Device TC33x/TC32x
Marking/Step (E)ES-AA, AA
Package see Data Sheet

10300AERRA

This Errata Sheet describes the deviations from the current user documentation.

Figure 1 Message buffer transfer from Message RAM to OBF

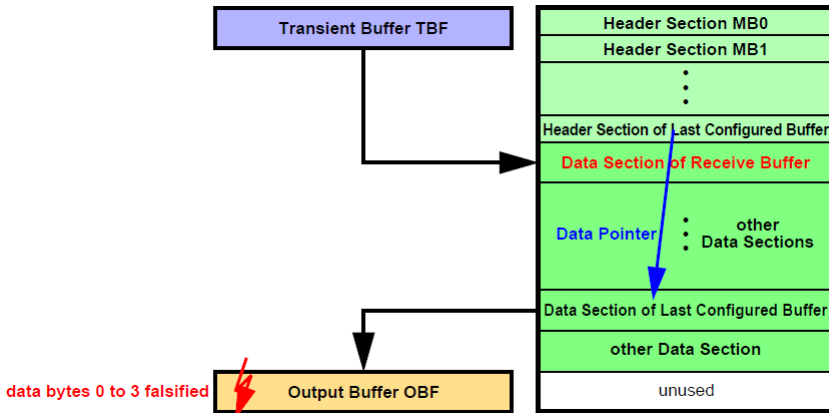
When the message buffer has its payload configured to maximum length (**PLC** = 127), the OBF word on address 00h (payload data bytes 0 to 3) is overwritten with unexpected data at the end of the transfer.

a) When a message is transferred from the Last Configured Buffer in the Message RAM to the OBF and **PLC** = 127 it may happen, that at the end of the transfer the OBF word on address 00h (payload data bytes 0 to 3) is overwritten with unexpected data (see [Figure 1](#)).

2) Ensure that the Data Section directly following the Header Partition is assigned to a transmit buffer.

Figure 2 Message buffer transfer from IBF to Message RAM

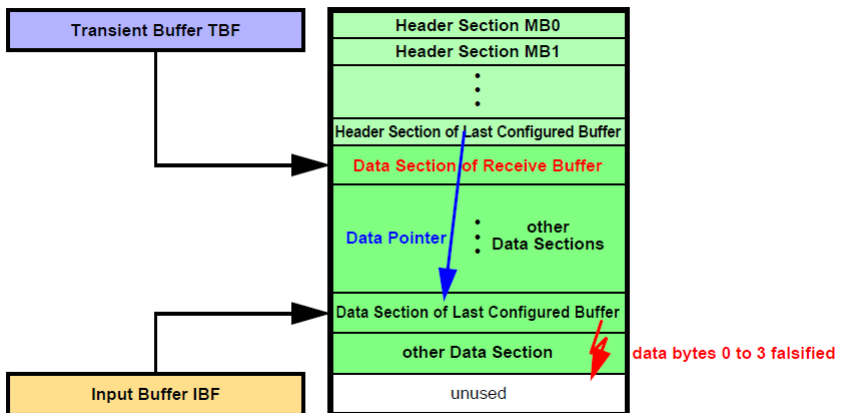
After the Data Section of the selected message buffer in the Message RAM has been written, one additional write access overwrites the following word in the Message RAM which might be the first word of the next Data Section.

b) When a message is transferred from IBF to the Last Configured Buffer in the Message RAM, it may happen, that at the end of the transfer of the Data Section one additional write access overwrites the following word, which may be the first word of another message's Data Section in the Message RAM (see [Figure 2](#)).

Figure 3 Message RAM Configurations

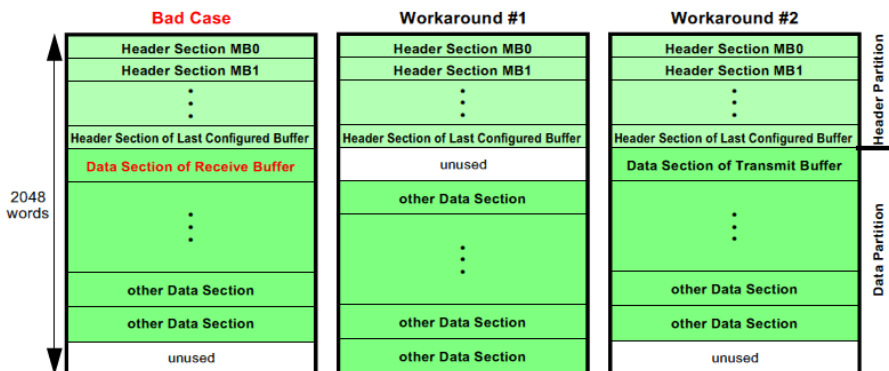
The erratum is limited to the case when (see [Figure 3](#) “Bad Case”):

Figure 4 Equivalent Circuitry for Analog Inputs

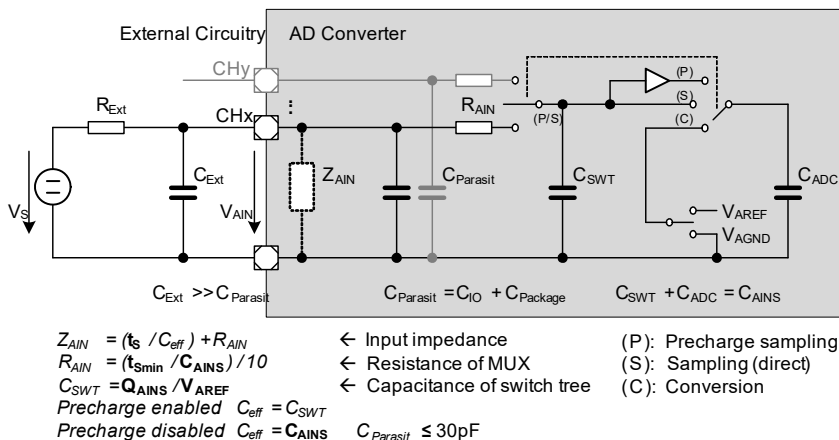
Figure “Equivalent Circuitry for Analog Inputs” will be modified in future revisions of the Data Sheet, including the term $C_{\text{Parasit}} \leq 30 \text{ pF}$, as shown in the following figure:

Figure 5 Interrupt Level vs. Pulse-Notify mode - Corner Case Example

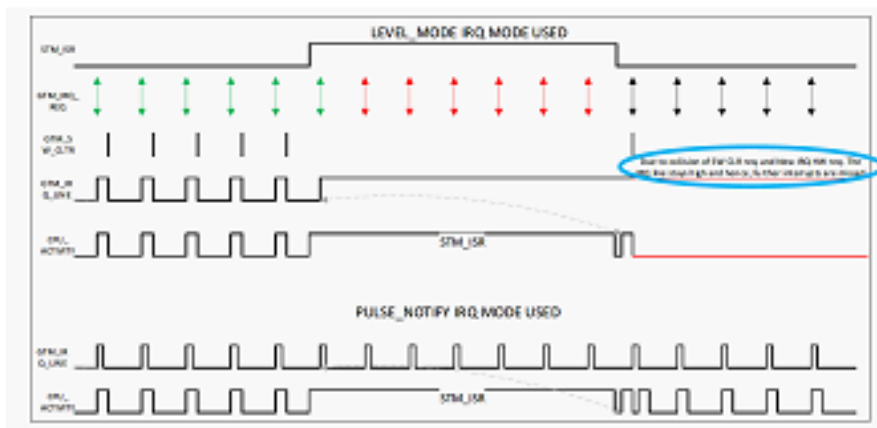
Figure “GTM interrupts” in chapter “GTM Implementation” of the TC3xx User’s Manual shows how the interrupt signal (GTM_IRQ_XXX) triggers an interrupt towards the Interrupt Router (IR), depending on IRQ_MODE.

As described in the text below this figure, while using Level mode, if more internal “interrupt” events are generated (i.e. two TOM channels generating a CCU0 interrupt), just one interrupt signal is sent to the IR, and no more interrupts are triggered until the SW clears the GTM_IRQ_XXX line towards the IR.

Hence, in Level Mode, in some scenarios where another interrupt request is generated by GTM while the ISR handle also requests a SW clear, then, as the interrupt event is dominant over the clear event (for simultaneous interrupt and clear events), GTM_IRQ_XXX is not cleared and remains high. As a consequence, the IR observes no transition on GTM_IRQ_XX. Thus, any forthcoming interrupt events in this scenario are lost as there is no chance to release the CPU IRQ when a collision happens as shown in Figure below.

If Pulse-Notify mode is selected, every internal trigger will be forwarded to the IR, irrespective of the time of occurrence and the clear event, as the pulse-notify leads to set and reset of GTM_IRQ_XXX as compared to only setting of the GTM_IRQ_XXX line in Level mode.
